CAPE COD COMMISSION

Project #: TR97006
Project: Falmouth Super Stop and Shop
Route 28 and Jones Road
Falmouth, MA

DECISION OF THE CAPE COD COMMISSION

Falmouth Stop & Shop/Teaticket Plaza Redevelopment, Falmouth, MA
September 18, 1997 Decision - #TR97006

Layout & Materials Plan

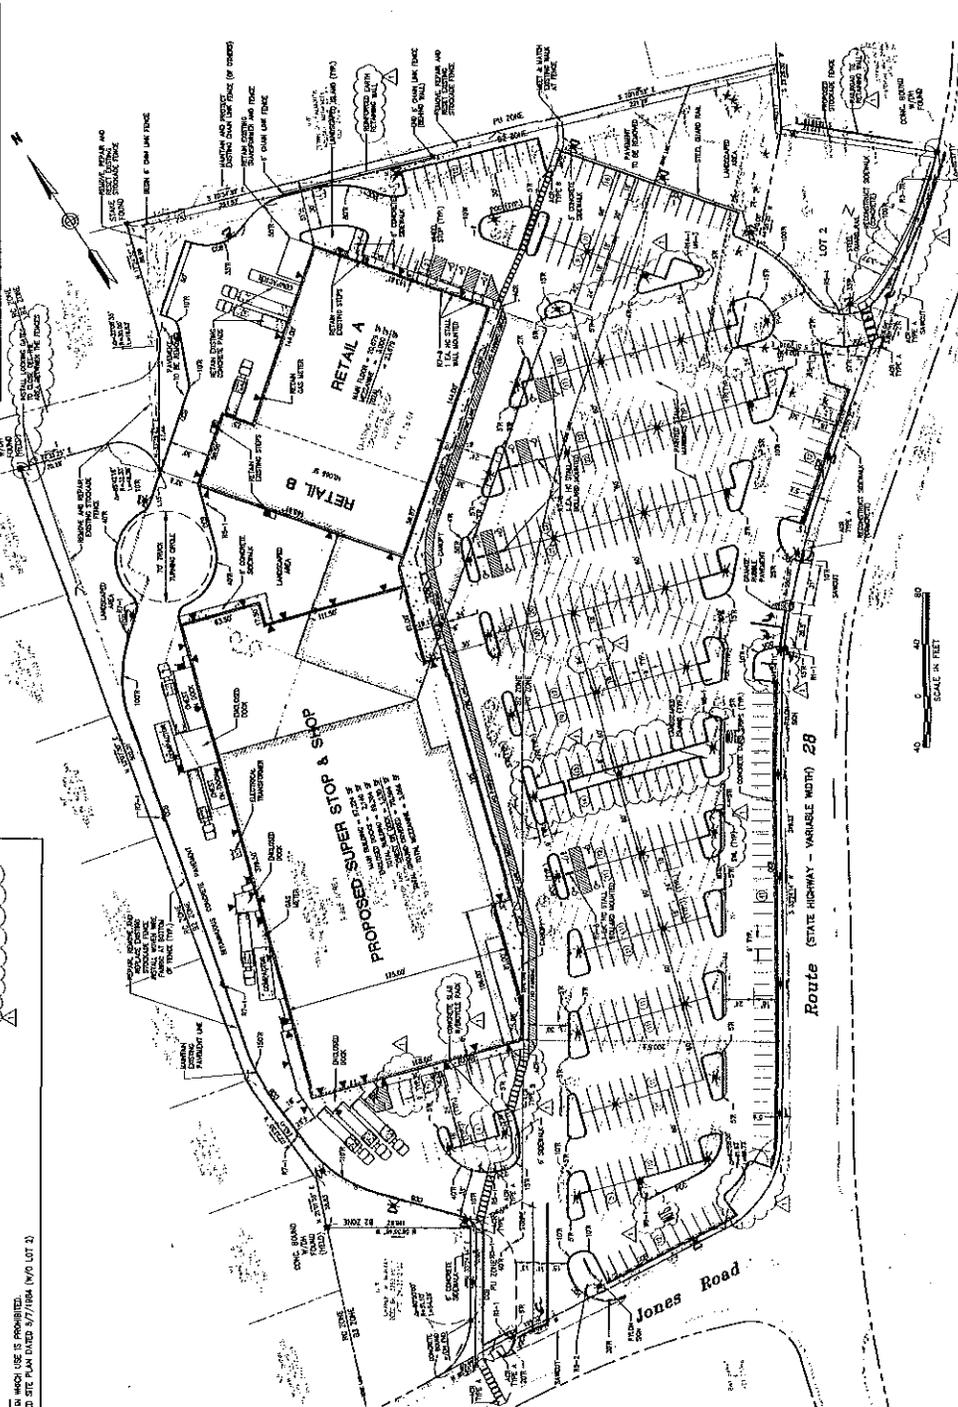
TR2. The Regional Policy Plan discourages additional curb cuts along roadways, especially congested roads such as Route 28. The applicant has proposed additional access to the site through a right-turn-in-only curb cut on Route 28, as shown on the Layout and Materials Plan, Sheet C-3, dated September 11, 1997. This access will provide perimeter access for truck traffic and separate them from the interior of the site, it will remove traffic from the main site drive, and it will provide for slightly better traffic flow along Route 28.

TR3. The applicant has proposed a number of measures to reduce employee traffic. These include bike racks, a carpooling program and direct deposit. These measures are consistent with the Commission's efforts to decrease dependence on private automobiles. The applicant has also proposed to maintain pedestrian facilities connecting the site to residential areas to the north, and has proposed a new pedestrian path and crosswalk connecting to the south of the site. The proposed pedestrian paths connect to pedestrian walkways in front of the stores and are shown on the Layout and Materials Plan, Sheet C-3, dated September 11, 1997.

TR4. The applicant has agreed to provide traffic calming in the form of signage and striping in the parking area to address concerns regarding safe site circulation as shown on the Layout and Materials Plan, Sheet C-3, dated September 11, 1997.

NR1. The existing shopping center site has 17 percent open space, provided in planted parking islands and narrow strips of green space along the site boundaries. To comply with Regional Policy Plan Minimum Performance Standard 2.5.1.4, which requires that the existing percentage of open space on redevelopment sites be maintained, the proposed redevelopment will provide 18 percent open space. The applicant has agreed to permanently restrict the open space.

TR1. The applicant shall construct main site access and the right-turn-in-only site access off Route 28 as shown on the Layout and Materials Plan, Sheet C-3, dated September 11, 1997.

TR2. The applicant shall provide bicycle racks, a carpooling program and direct deposit option for employees to decrease dependence on private automobiles. The applicant shall construct and maintain pedestrian paths and crosswalks connecting the site to residential areas to the north and south of the site as shown on the Layout and Materials Plan, Sheet C-3, dated September 11, 1997.

TR3. The applicant shall provide traffic calming in the form of signage and striping in the parking area to address concerns regarding safe site circulation as shown on the Layout and Materials Plan, Sheet C-3, dated September 11, 1997.

NR1. Prior to any development on the site, the applicant shall provide the Cape Cod Commission with a deed restriction to be approved by Commission counsel which provides that the 18% open space shown on the Layout and Materials Plan, Sheet C-3, dated September 11, 1997, shall remain as permanent open space. The restriction, shall be recorded at the Registry/Land Court by the applicant prior to issuance of a Certificate of Compliance from the Commission.

Landscaping Plan

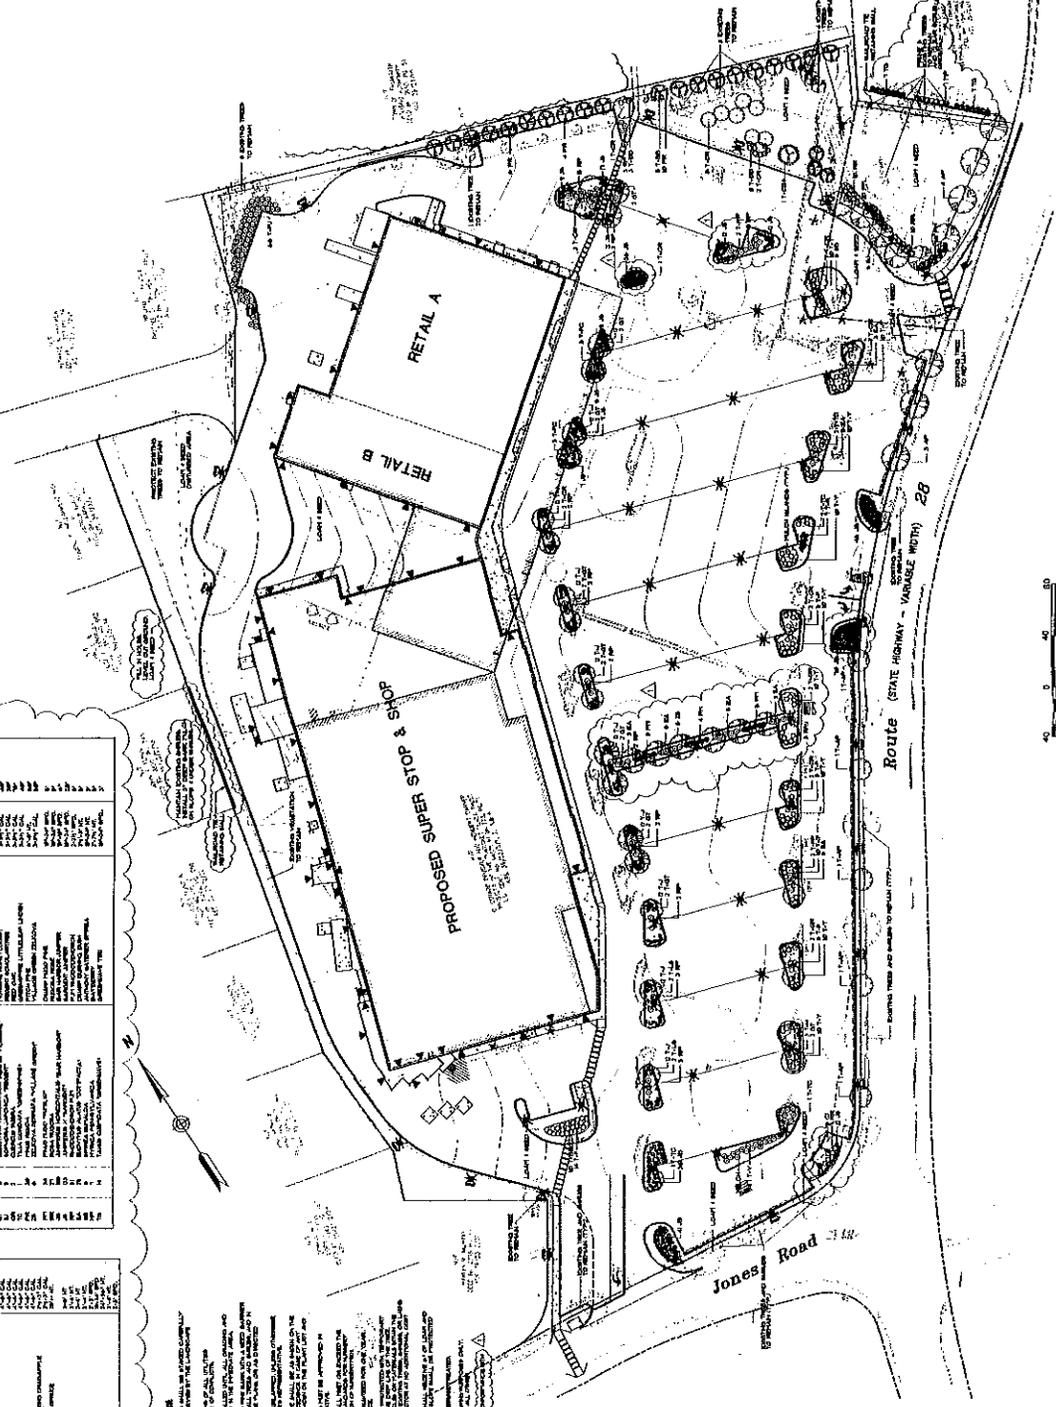
CC3. The applicant has improved landscaping on the site through the provision of a 10-foot wide landscaped island in the center of the parking lot, increased landscaping at the corner near the intersection of Route 28 and Jones Road, and additional landscaping to the left of the main site entrance, as shown on the Landscape Plan, Sheet C-6, dated September 11, 1997. The inclusion of a landscaped area on a portion of the adjacent 19,000 square foot parcel provides some buffering for the project, and enhanced plantings of various heights in the parking lot islands will improve the visual character of the site. The applicant has proposed an irrigation system incorporating drip irrigation and spray heads to maintain landscaped areas.

CC2. The applicant shall install the landscaping as agreed to on the Landscape Plan, Sheet C-6, dated September 11, 1997, including a 10-foot wide planted island in the parking area and

landscape improvements to improve buffers to abutters. Improvements shall include a five-foot wide low planting area on the VFW property adjacent to the site; a woven wire fence below the existing fence to the rear of the site; two locked gates to limit access to the area between the two existing fences to the rear of the site; railroad ties and bark mulch to stabilize the bank behind the loading area of the site; and general clean-up, leveling and loaming and seeding of the entire area between the two fences at the rear of the site.

A-1

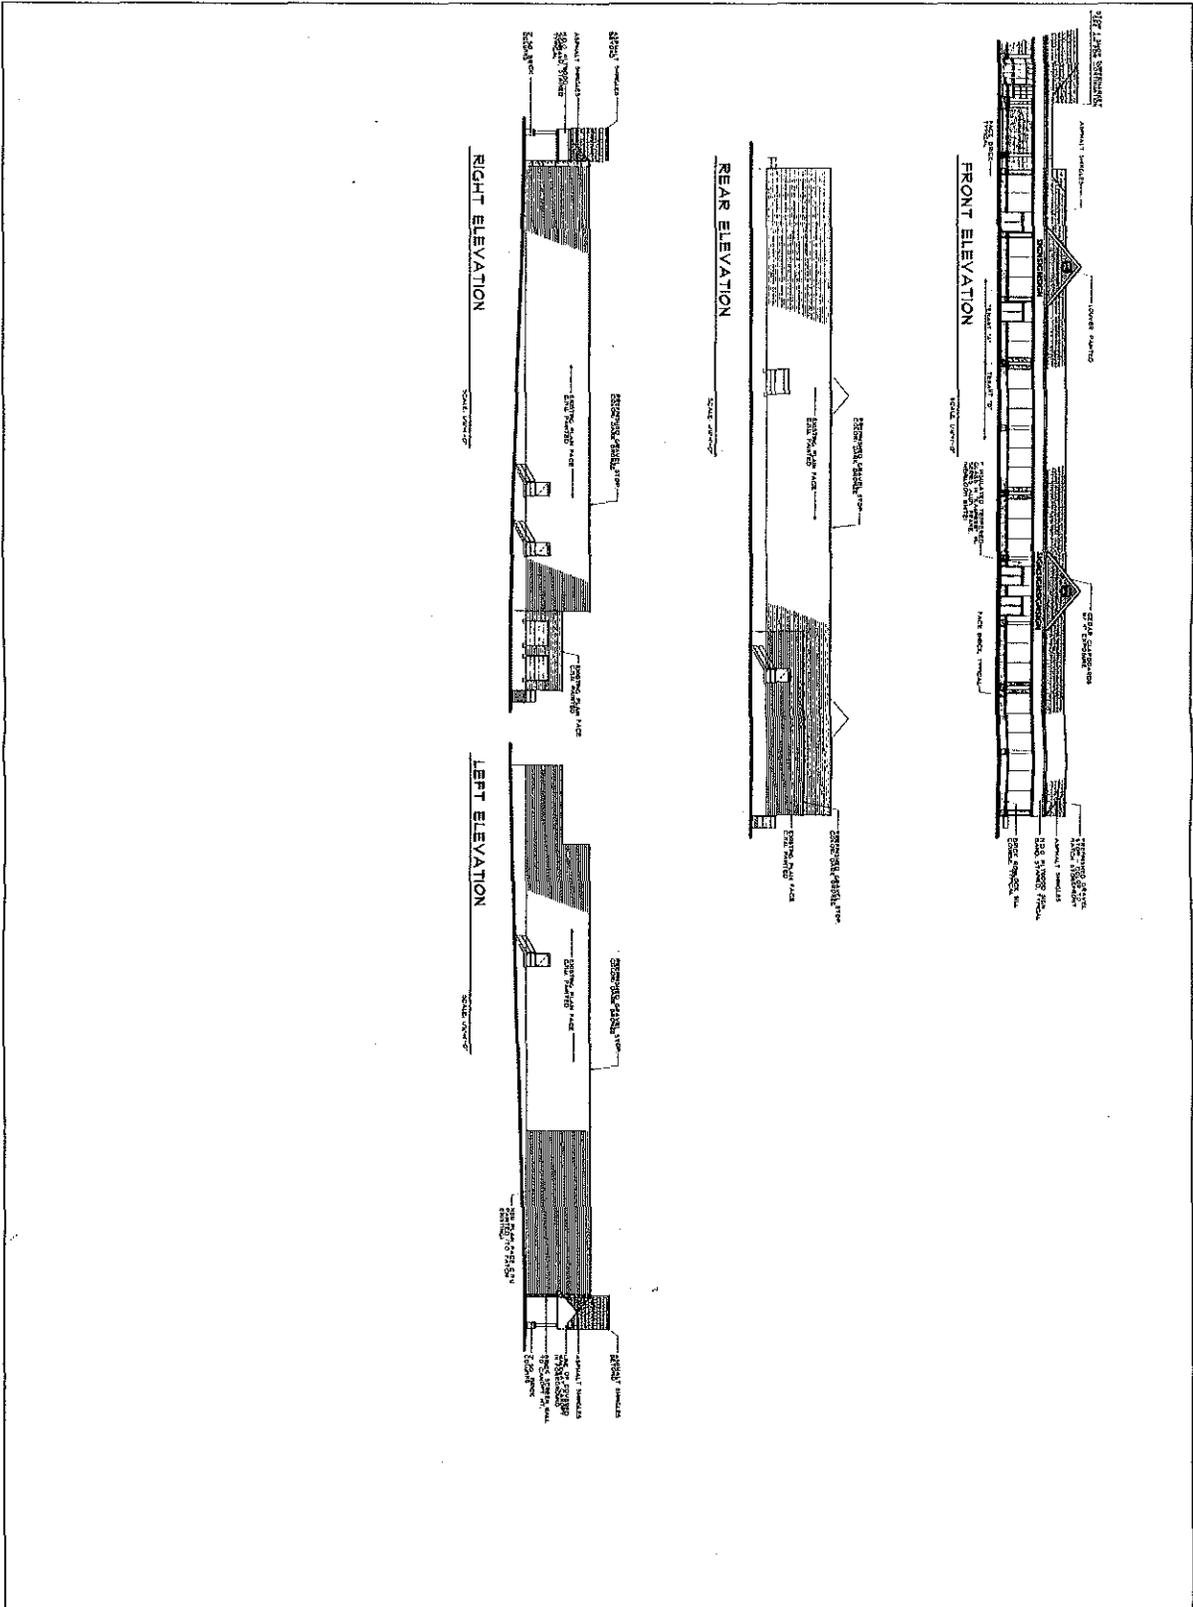
CC2. The applicant has proposed a new building facade for Stop & Shop, shown on Proposed Supermarket Exterior Elevations, Sheet A-1, dated January 31, 1997, revised April 2, 1997, which incorporates traditional materials with use of wood clapboards and trim, brick sills, and gabled roof elements. The elevation also incorporates several large detailed glass areas which help to break up the large building mass. The facade of the retail building, shown on Proposed Retail Store Exterior Elevations, Sheet A-2, dated January 31, 1997, revised April 2, 1997, includes similar design elements, with wood clapboards on gable roof details, and a wood sign band, making the building more consistent with the Commission's Design Guidelines.

CC1. The applicant shall construct the new building facades as shown on the Proposed Supermarket and Retail Store Exterior Elevations, Sheets A-1 and A-2, dated January 31, 1997, revised April 2, 1997.
